2020 Corvette: Recall Notice: #N202309350: Non-Compliance - Interior Trunk Release Button Inoperative Ten Minutes After Power Off

Subject: N202309350 — Interior
Trunk Release Button
Inoperative Ten Minutes
After Power Off

Models: 2020 Chevrolet Corvette

Release Date: August 2020

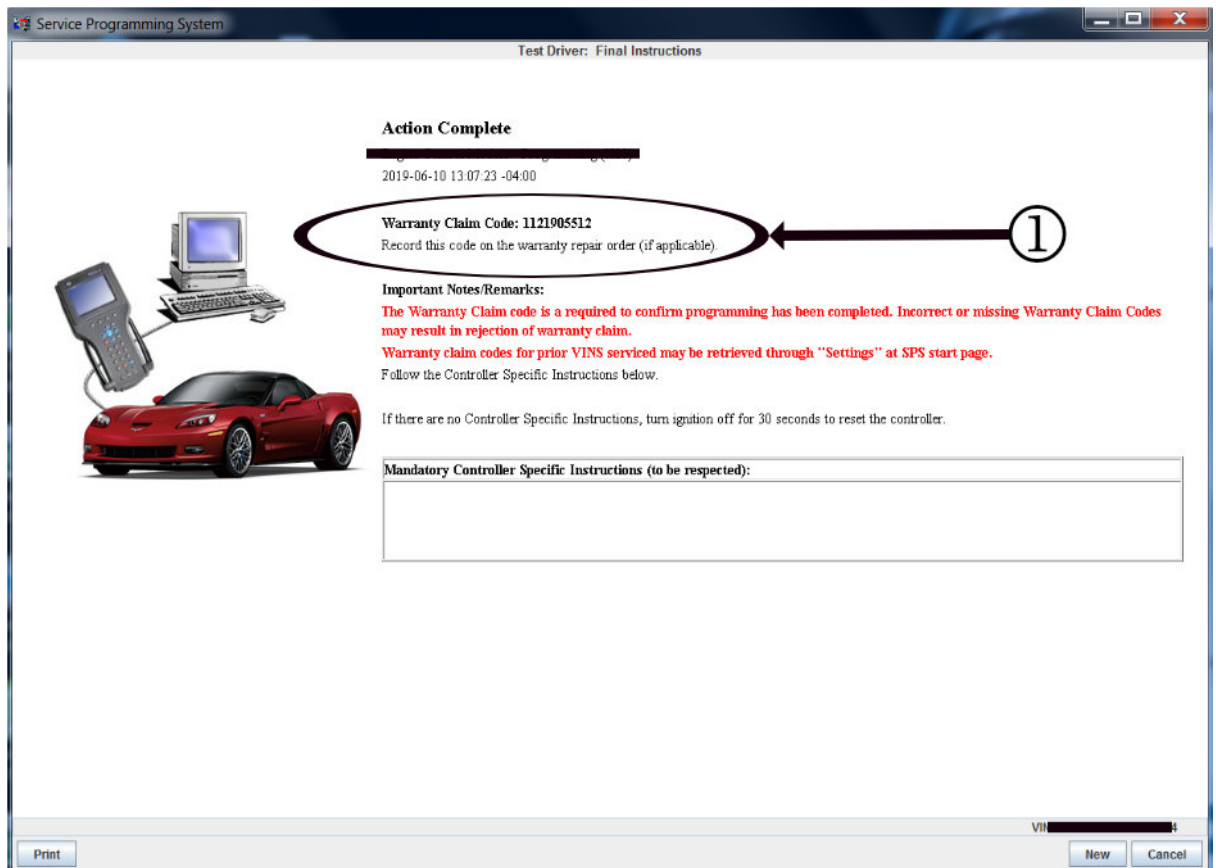
Important: If the Same Calibration/Software Warning is noted on the SPS Summary screen, record the warranty claim code (WCC) and select OK and follow screen instructions. After a successful programming event, the WCC is located in the Service Programming System dialogue box of the SPS Summary screen. No further action is required. Refer to the Warranty section of the bulletin.

1. Reprogram the body control module. Refer to *K9 Body Control Module: Programming and Setup* in SI.
